**RESPONSE TO FREEDOM OF
INFORMATION ACT (FOIA) REQUEST****JIA - 96-351**

NRC INSPECTION
QUESTION/RESPONSE TRACKING FORM.

AIT FOR ROD CONTROL SYSTEM
QUESTION AND ANSWER STATUS

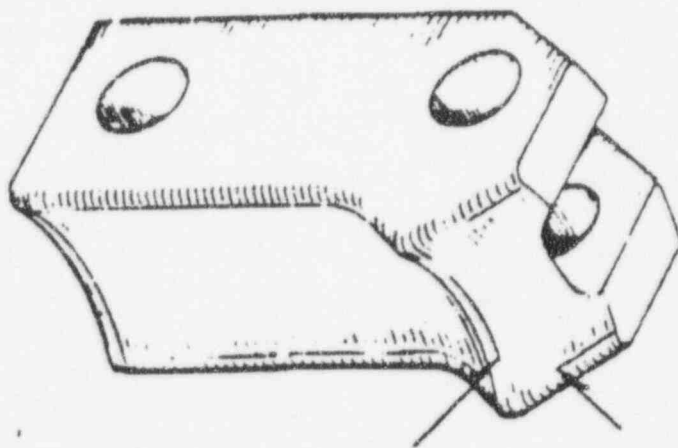
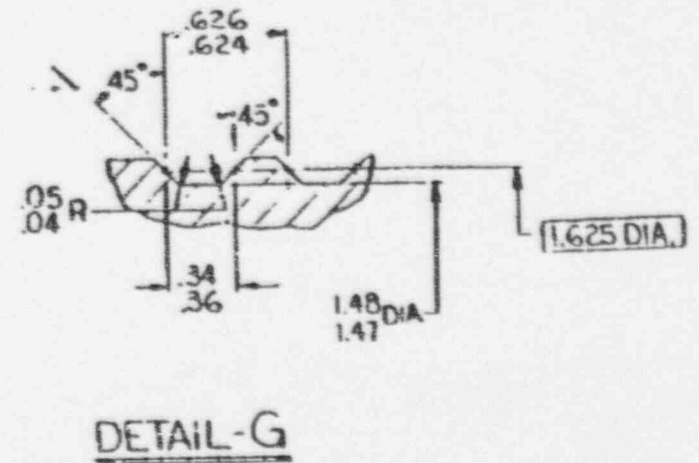
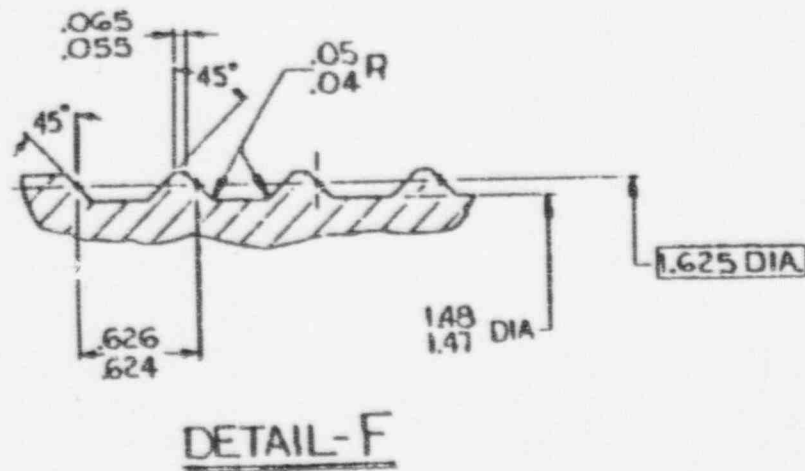
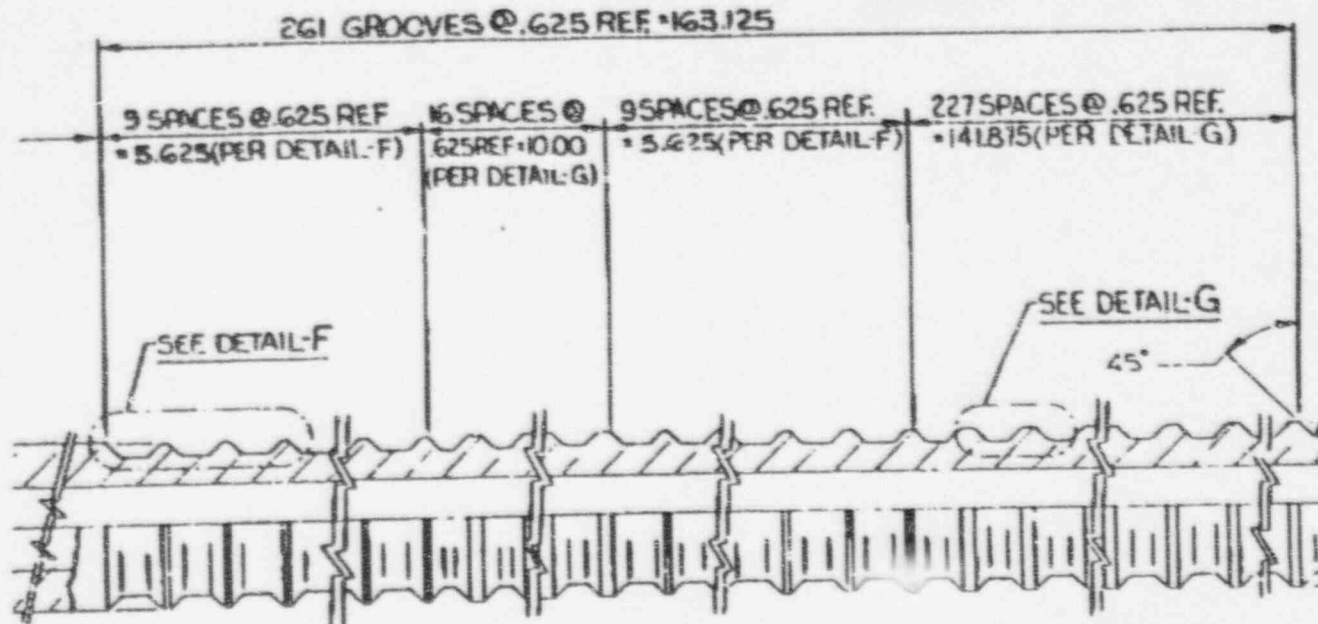
QUESTION: Provide drawing of lift rod and grippers, showing mechanical dimensions and tolerances. A force diagram of the above components, i.e. showing lift force of lift coil and spring/coil forces acting on movable + stationary grippers

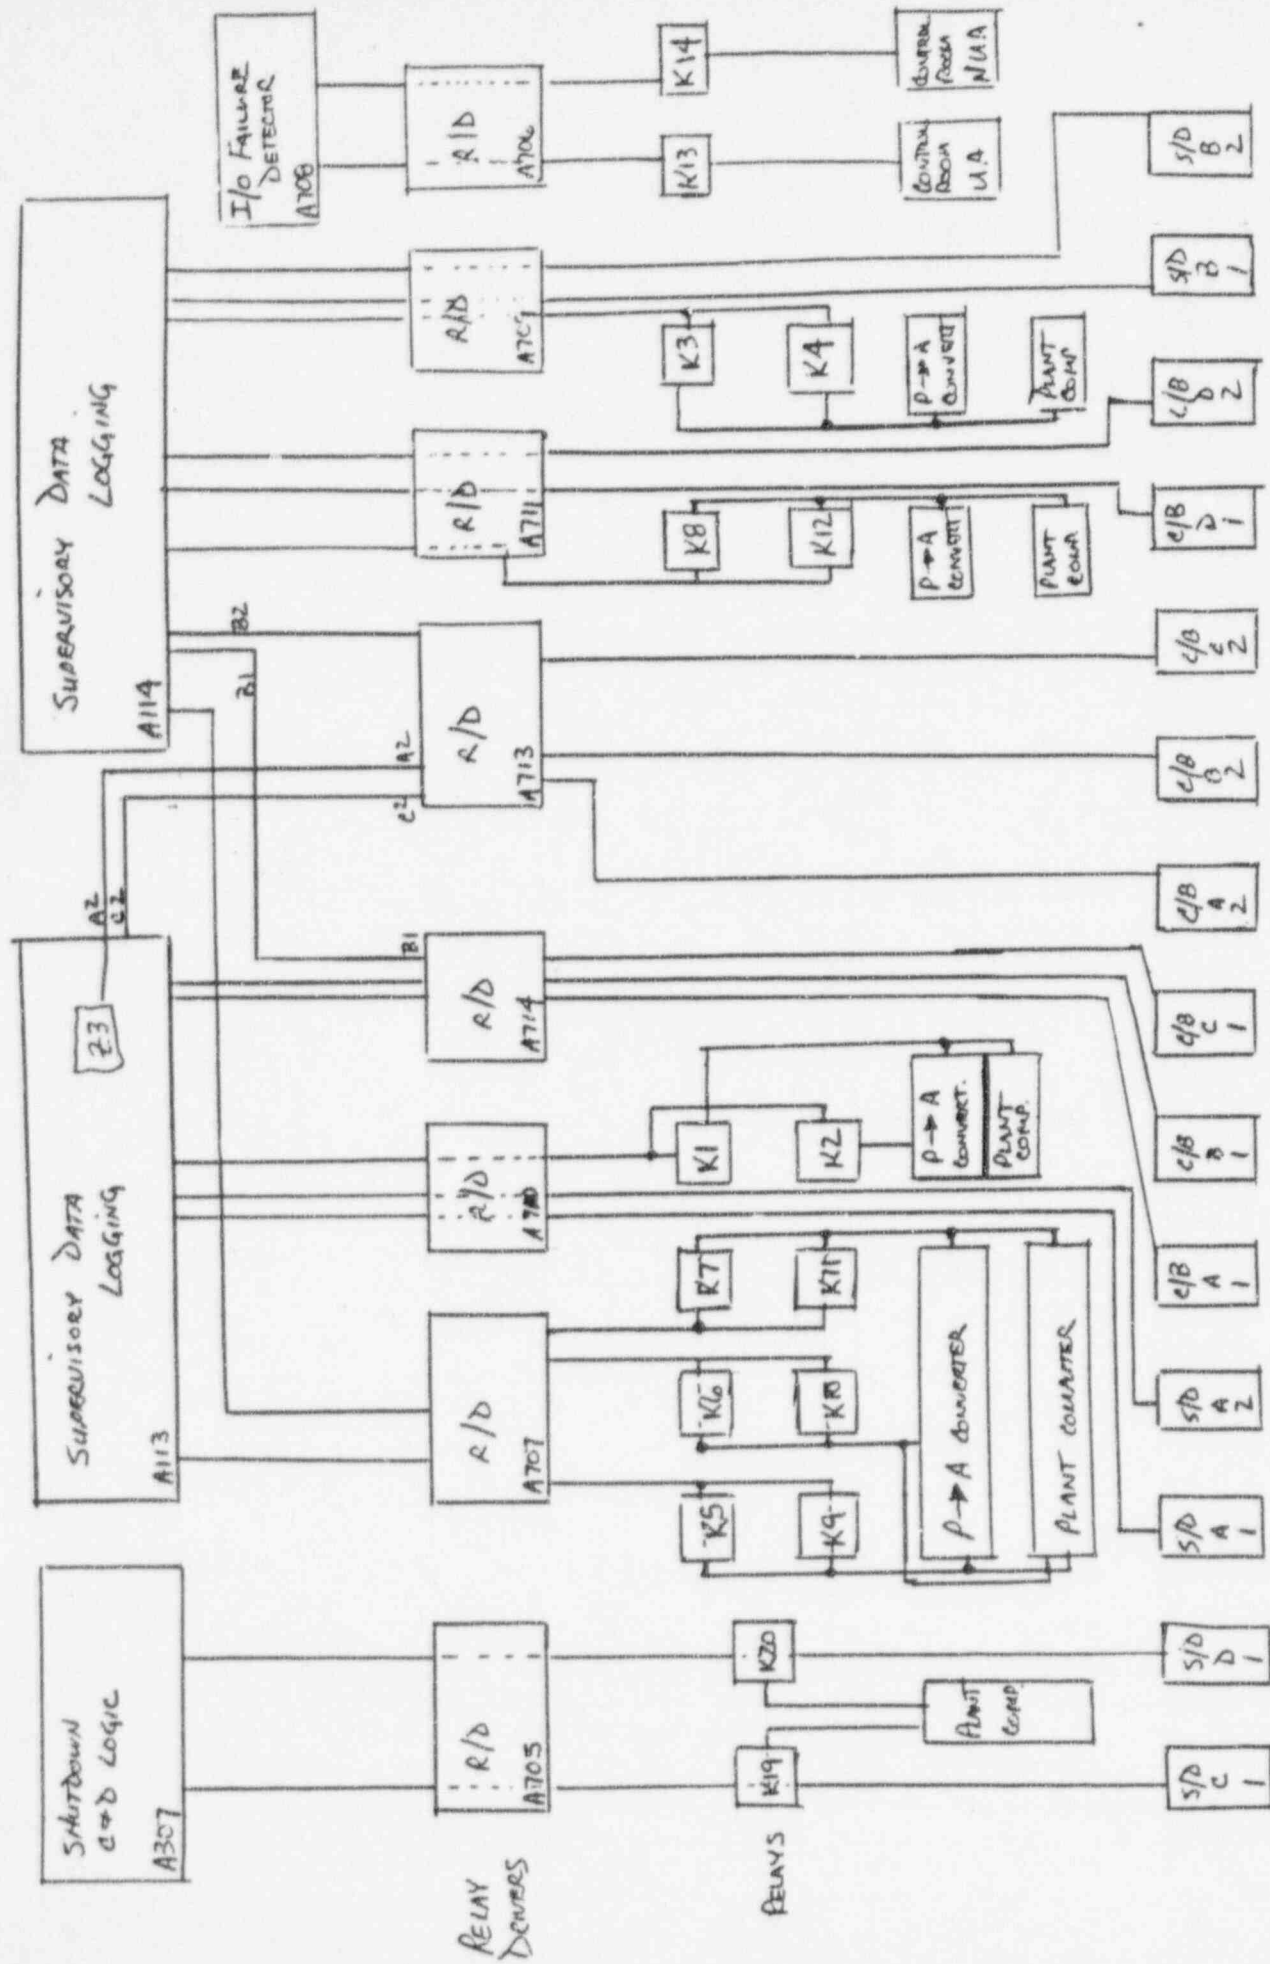
QUESTION: 17 failures have been noted on Z3
11 were in A113 slot. What ^{Relay Driver +} counter is driven
by Z3 in A113? What is the maintenance history
of that counter + Relay Driver locations.

RESPONSE: Z3 on A113 drives the step counter for C/B-A2 through
Relay Driver A713. On Monday 5/24 C/B-A2 counter did not move on demand
and gave an urgent failure alarm. " This was linked to the blown lift coil detector caused
by the lamp socket. It was never replaced or suspected of mechanical
difficulties throughout this troubleshooting effort. - see over -
